STATE OF RHODE ISLAND AND PROVIDENCE PLANTATION  
DEPARTMENT OF TRANSPORTATION  
RHODE ISLAND CONTRACT NO.2012-CB-046  
FEDERAL-AID PROJECT NO. FAP Nos: BRO-0200(007)

**Washington #200 - Pedestrian Bridge & Warren Avenue Bridge #464**

NOTICE TO PROSPECTIVE BIDDERS

ADDENDUM NO. 3 Prospective bidders and all concerned are hereby notified of the following changes in the Plans, Specifications, Proposal and Distribution of Quantities for this contract. These changes shall be incorporated in the Plans, Specifications, Proposal and Distribution of Quantities, and shall become an integral part of the Contract Documents.

**REVISION TO SHEET NO. 95**

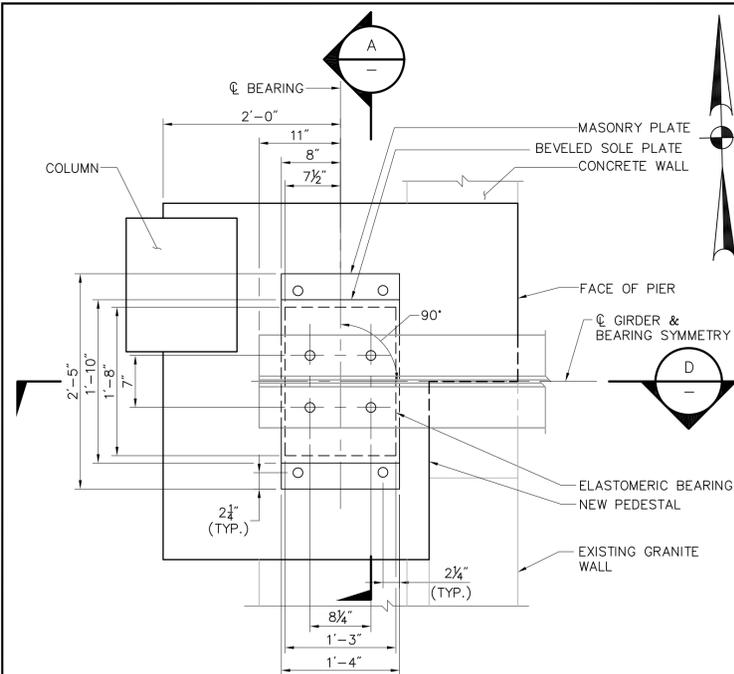
11. SET 3 SHEET NO. 95 – JOINT ELIMINATION DETAILS  
Modify the plan as shown on Sketch No. 10 attached to this Addendum No. 3. Reinforcing steel and splice are be clarified.

1. MECHANICAL COUPLERS SHALL BE ZAP SCREWLOK SYSTEM (OR APPROVED EQUAL) AND INSTALLED IN ACCORDANCE WITH THE MANUFACTURER'S RECOMMENDATIONS. PAYMENT FOR COUPLERS SHALL BE INCLUDED UNDER ITEM CODE 810.9901.
2. MECHANICAL COUPLERS SHALL BE INSTALLED WITH SCREW HEAD ORIENTATED SUCH THAT A MAXIMUM CONCRETE COVER IS ATTAINED.
3. PROPOSED SPLICE BAR (DETAIL 1) SHALL BE UNCOATED ASTM A706 REINFORCING STEEL. THE UNCOATED REINFORCING STEEL AND WELDED FIELD SPLICE SHALL BE PAID FOR UNDER ITEM CODE 810.9901.

**SPAN 14 AND 15 BEARING REPLACEMENT**

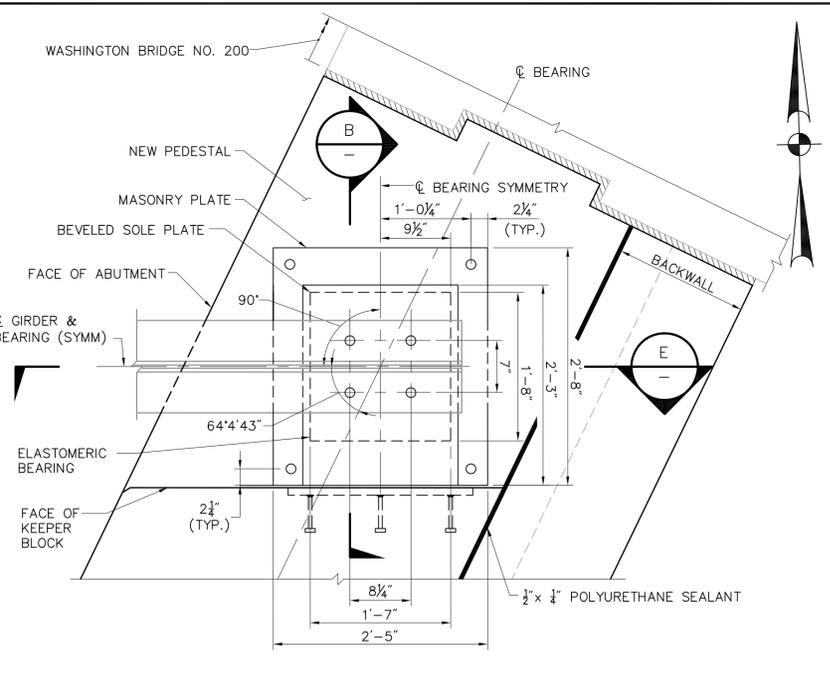
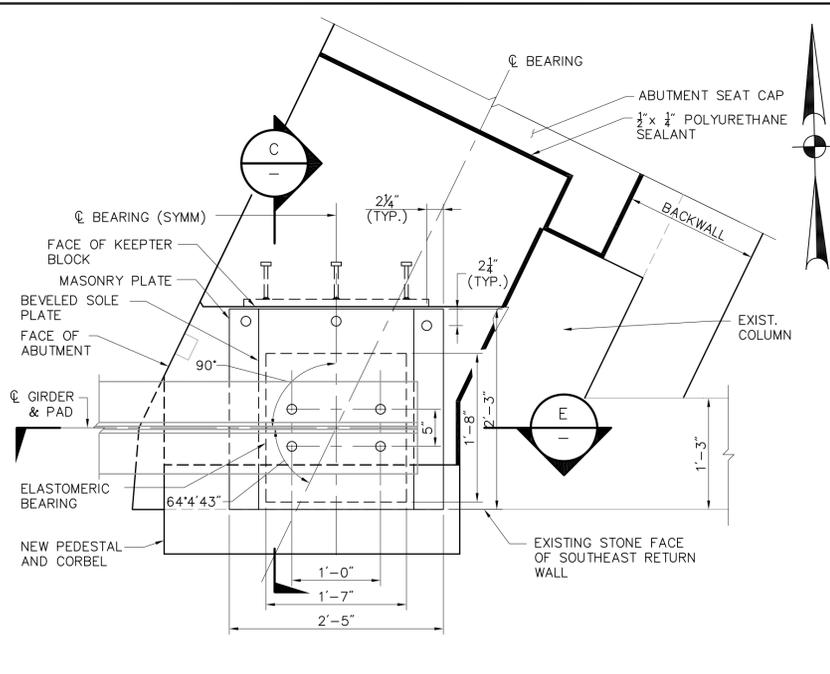
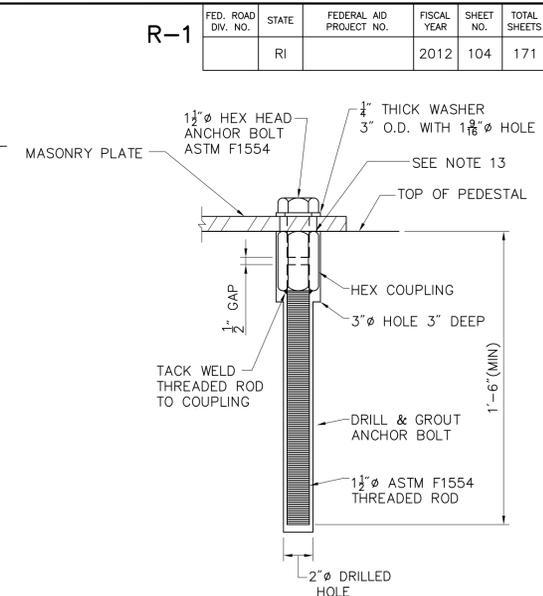
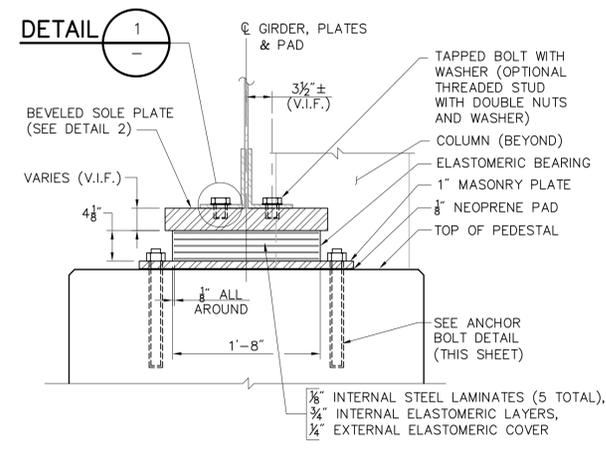
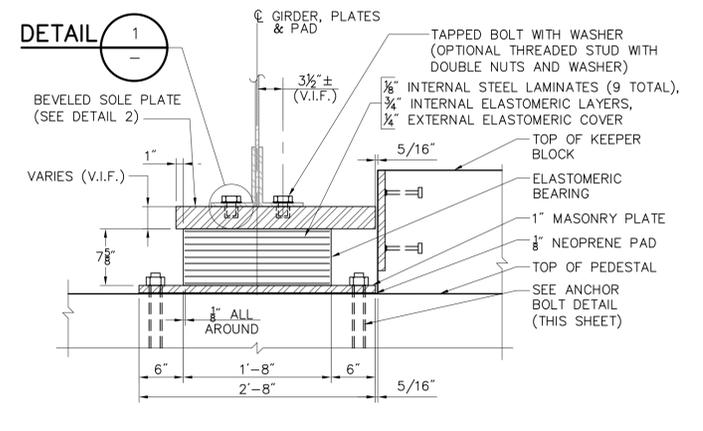
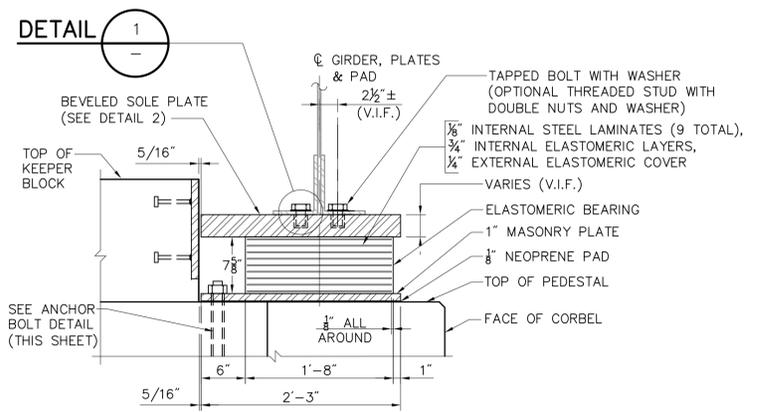
13. SET 3 SHEET NO. 104 - SPAN 14 AND 15 BEARING REPLACEMENT

Delete Sheet No. 104 in its entirety and replace it with Sheet Nos. 104 (R-1) attached to this Addendum No. 3. The drawing has been restored.

ENTIRE SHEET REPLACED BY ADDENDUM NO.3

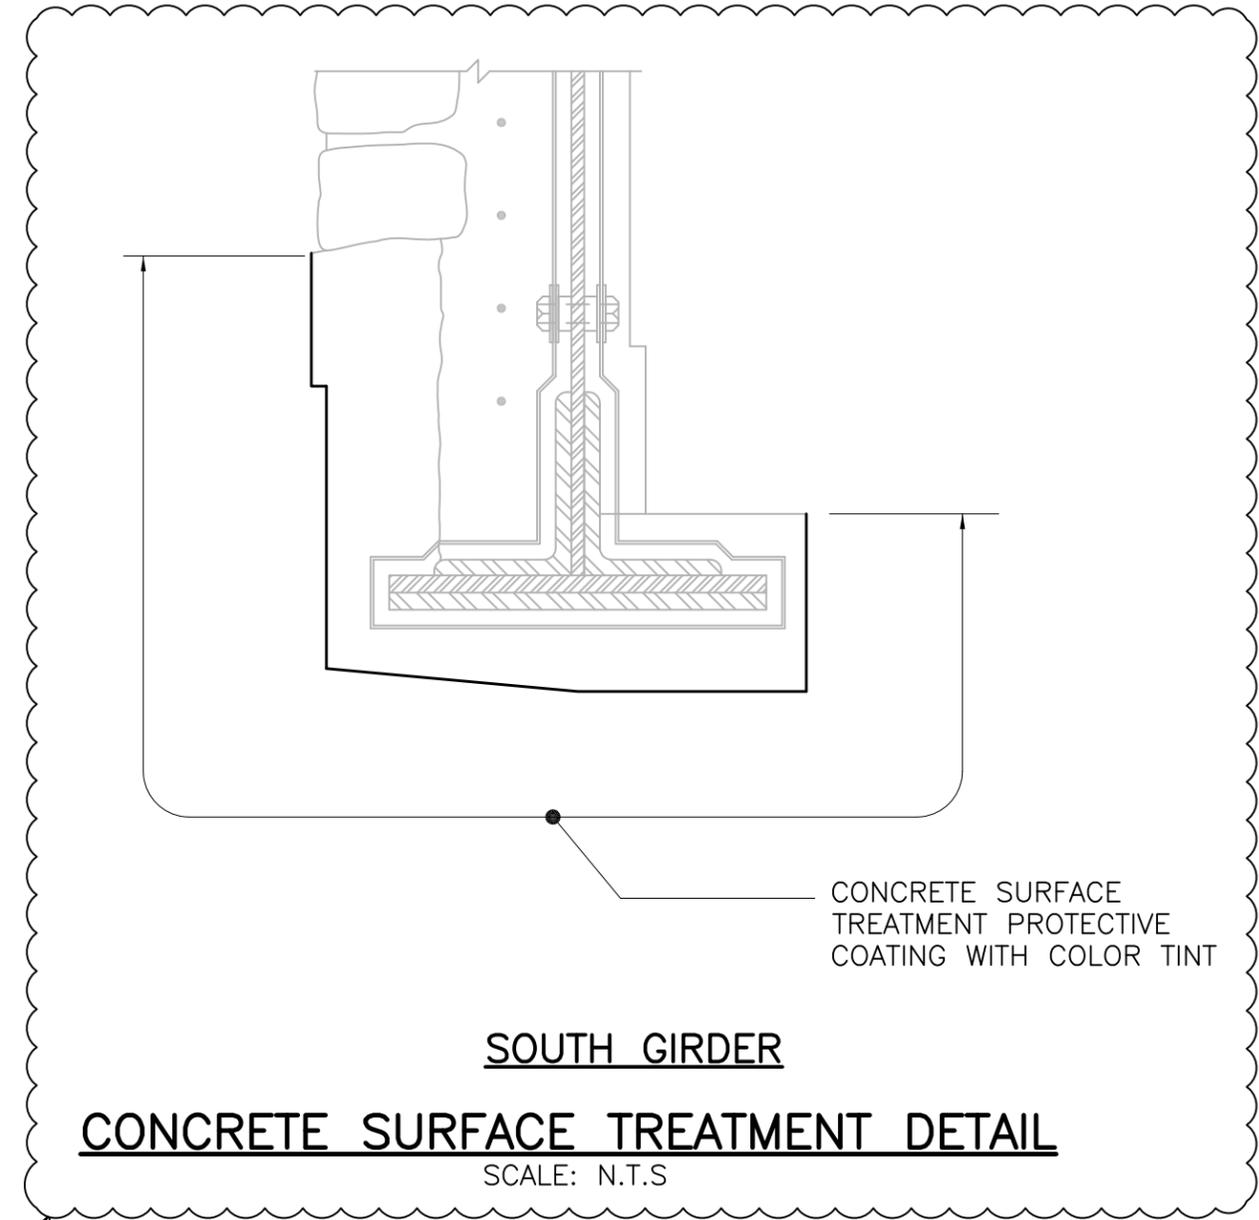
14. SET 3 SHEET NO. 137 – UTILITY SUPPORT DETAILS 1

Modify the plan as shown on Sketch No. 11 attached to this Addendum No. 3. Note 5 has been modified.
